## Office Action Summary

10/776,487

YU, HO-YUAN

Khiem D. Nguyen

**Fig. 18**

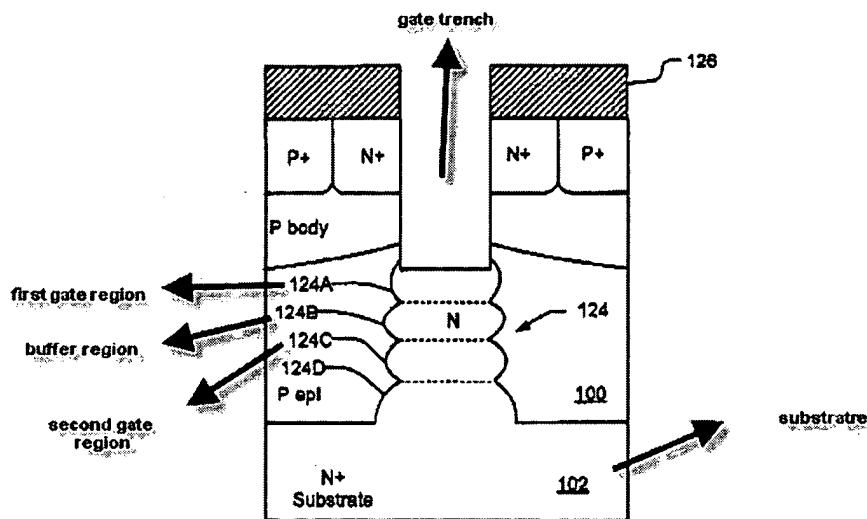
In re claim 21, **Darwish** discloses a method for fabricating a dual gate structure for a field effect transistor (FET), the method comprising: in sequence, etching a gate trench in a surface of a semiconductor substrate **100, 102**; forming a first gate region **124A** at the bottom of the gate trench; implanting a buffer region 124B beneath the first gate region **124A**; and implanting (see col. 9, lines 2-19 and FIGS. 17A-B and 18) a

second gate region **124C** beneath the buffer region **124B**, wherein the second gate region **124C** is formed entirely beneath the first gate region **124A**; wherein said first gate region **124A** and said second gate region **124C** together form said dual gate structure (see col. 7, line 55 to col. 8, line 10 and FIG. 18, for example).

In re claim 22, as applied to claim 21 above, Darwish discloses all claimed limitations including the limitation wherein the method further comprising forming a sidewall spacer to establish a width of the first gate region 124A (see FIG. 5G and 18, for example).

In re claim 23, as applied to claim 21 above, **Darwish** discloses all claimed limitations including the limitation wherein the method further comprising forming a sidewall spacer to establish a width of the buffer region **124B** (see FIG. 5G and 18, for example).

In re claim 24, as applied to claim 21 above, **Darwish** discloses all claimed limitations including the limitation wherein the method further comprising forming a sidewall spacer to establish a width of the second gate region **124C** (see FIG. 5G and 18, for example).

Fig. 18

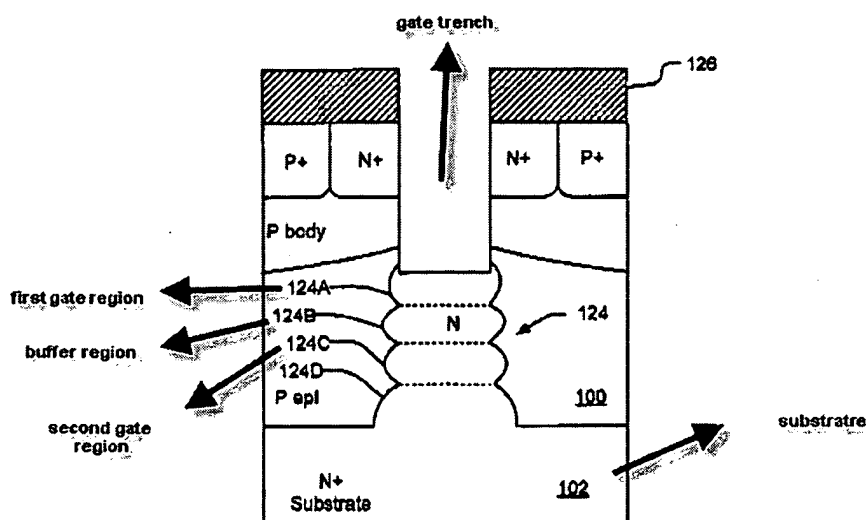
In re claim 26, **Darwish** discloses a method for fabricating a dual gate structure for a field effect transistor (FET), the method comprising: etching a gate trench in a surface of a semiconductor substrate **100**, **102**; forming a first gate region **124A** at the bottom of the gate trench, implanting a buffer region **124B** beneath the first gate region **124A**; and implanting (see col. 9, lines 2-19 and FIGS. 17A-B and 18) a second gate region **124C** beneath the buffer region **124B**, wherein the second gate region **124C** is formed entirely beneath the first gate region **124A**; wherein said first gate region **124A** and said second gate region **124C** together form said dual gate structure (see col. 7, line 55 to col. 8, line 10 and FIG. 18, for example).

In re claim 27, as applied to claim 26 above, **Darwish** discloses all claimed limitations including the limitation wherein the method further comprising forming a sidewall spacer to establish a width of the first gate region **124A** (see FIGS. 5G and 18, for example).

In re claim 28, as applied to claim 26 above, **Darwish** discloses all claimed limitations including the limitation wherein the method further comprising forming a sidewall spacer to establish a width of the buffer region **124B** (see FIGS. 5G and 18, for example).

In re claim 29, as applied to claim 26 above, **Darwish** discloses all claimed limitations including the limitation wherein the method further comprising forming a sidewall spacer to establish a width of the second gate region **124C** (see FIGS. 5G and 18, for example).

Fig. 18

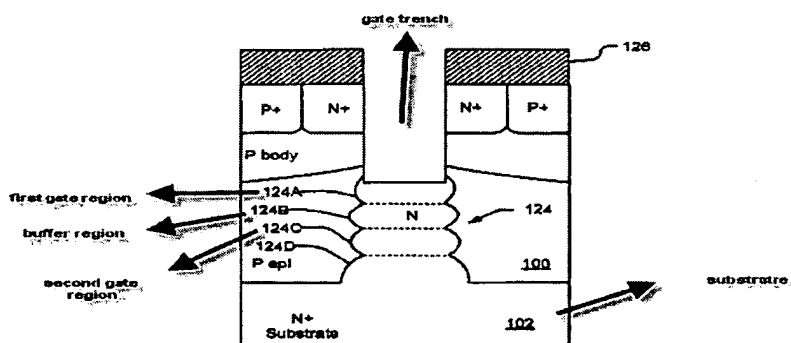
In re claim 30, **Darwish** discloses a method for fabricating a dual gate structure for a field effect transistor the method comprising: etching a gate trench in a surface of a semiconductor substrate **100, 102** (see FIG. 18);

forming a first gate region **124A** at the bottom of the gate trench; implanting a buffer region **124B** beneath the first gate region **124A**; and after implanting the buffer region **124B**, implanting (see col. 9, lines 2-19 and FIGS. 17A-B and 18) a second gate region **124C** beneath the buffer region **124B**, wherein said second gate region **124C** is formed entirely beneath said first gate region **124A**; wherein said first gate region **124A** and said second gate region **124C** together form said dual gate structure (see col. 7, line 55 to col. 8, line 10 and FIG. 18, for example).

In re claim 31, as applied to claim 30 above, **Darwish** discloses all claimed limitations including the limitation wherein the method further comprising forming a sidewall spacer to establish a width of the first gate region **124A** (see FIGS. 5G and 18, for example).

In re claim 32, as applied to claim 30 above, **Darwish** discloses all claimed limitations including the limitation wherein the method further comprising forming a sidewall spacer to establish a width of the buffer region **124B** (see FIGS. 5G and 18, for example).

In re claim 33, as applied to claim 30 above, **Darwish** discloses all claimed limitations including the limitation wherein the method further comprising forming a sidewall spacer to establish a width of the second gate region **124C** (see FIGS. 5G and 18, for example).

In re claim 34, as applied to claim 30 above, **Darwish** discloses all claimed limitations including the limitation wherein the method further comprising forming a first sidewall spacer to establish a width of the buffer region **124B**, and forming a second

sidewall spacer to establish a width of the second gate region **124C**, wherein the second sidewall spacer is thicker than the first sidewall spacer (see FIGS. 5G and 18, for example).
